# FOR PERCOLATION TESTING AND SITE EVALUATION

RE: PERCOLATION TEST RESULTS, Tax Map 1, Parcel 251; James L. Bullington Property, West side of Bennett Road at South Branch of Patapsco River, A-530984

PERCOLATION TEST PLAN, Bullington Property-Bennett Road (for Brenda Lowrey),

RE: Property Unusable for On-Site Sewage Disposal Systems -Improper soil conditions;

JOB No. A9-5150

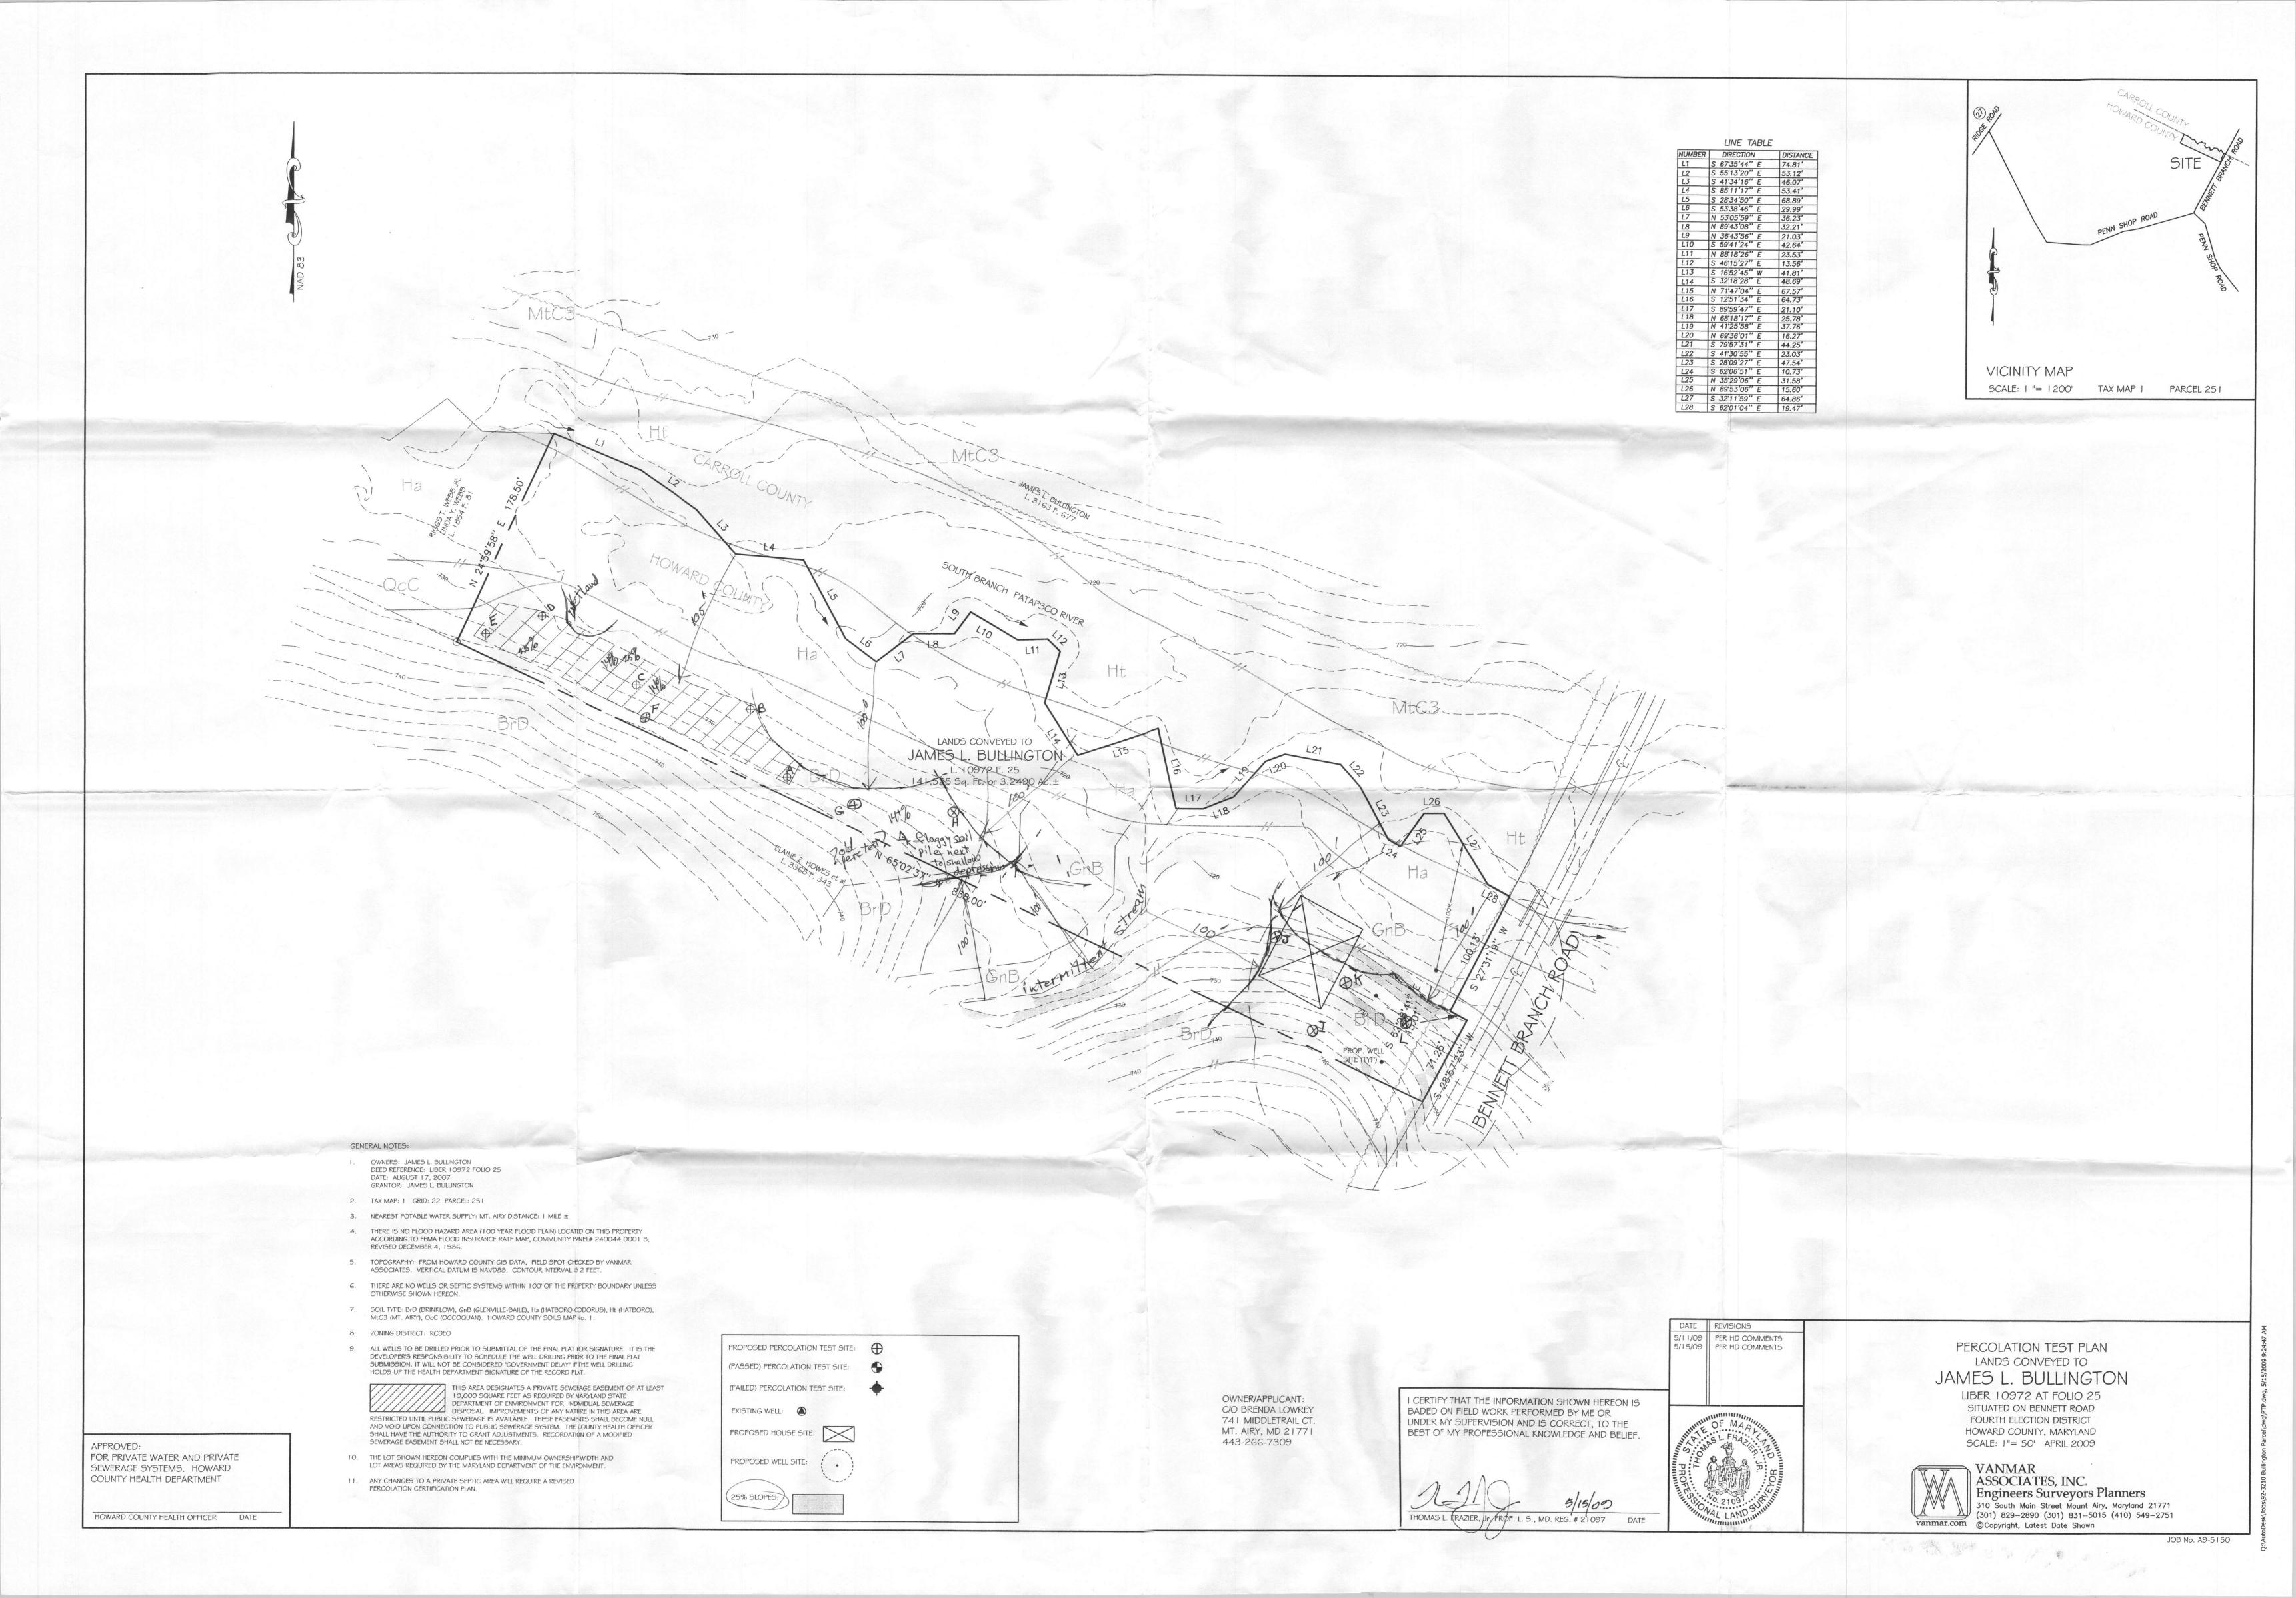
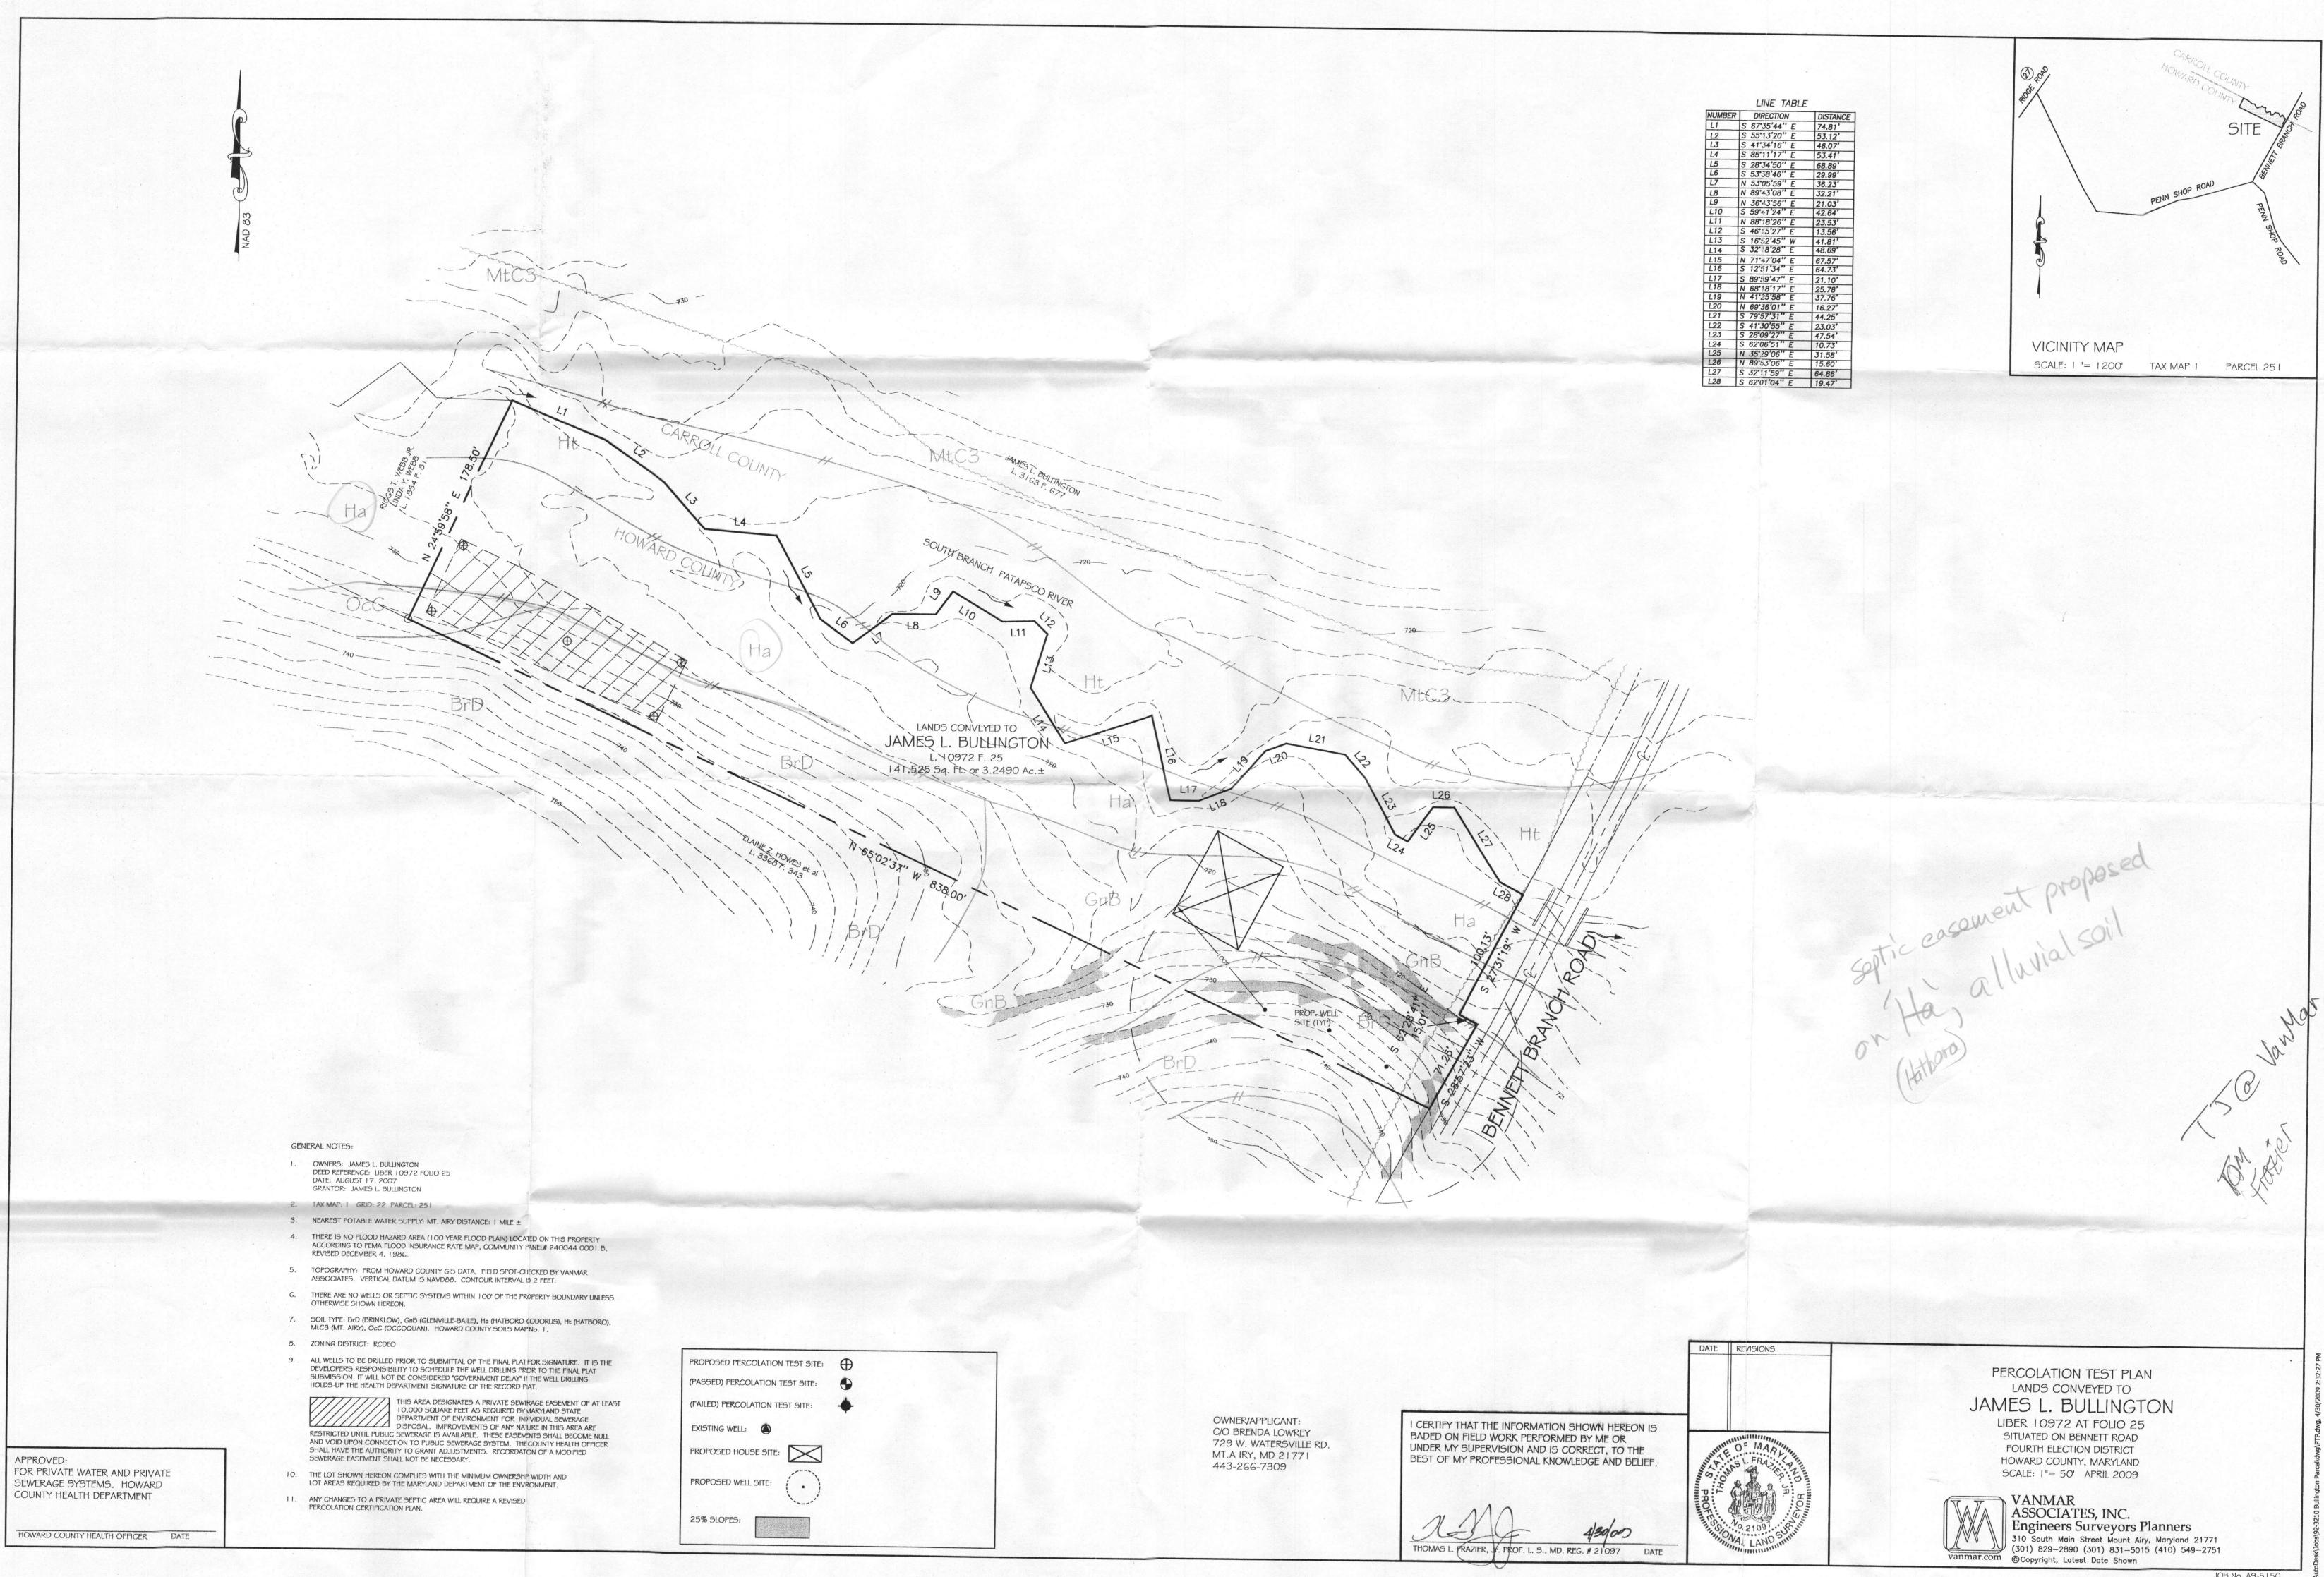
A percolation test date may be set after correction of the Perc Test Plan.

A portion of the proposed septic easement and to proposed percolation test locations are shown in the Hatboro (Ha) soil map unit. The Hatboro soil is an alluvial soil and regulated in Maryland as 'Do Not Test'.
